PAPER ROLLER (STEPPER MOTOR)

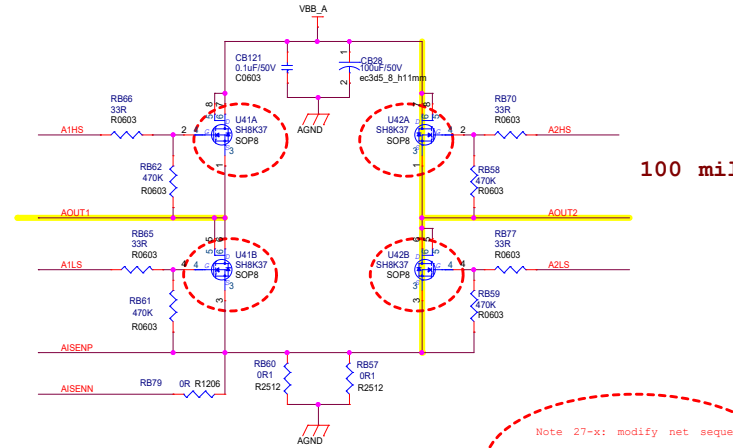
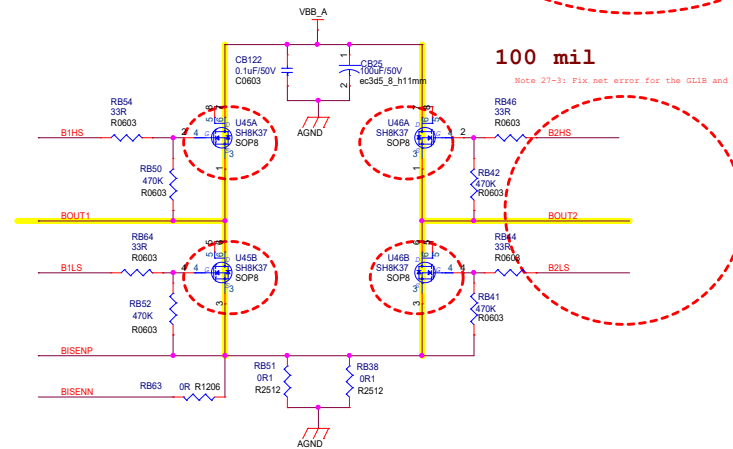
Note 27-1: Reserved two resistor RB345/RB346 to swap control STEP ENABLE
Note 27-2: Remove UB5

Note 27-4: Change Driver IC to DRV8711DCPR

Note 27-3: Fix net error for the GL18 and GR18
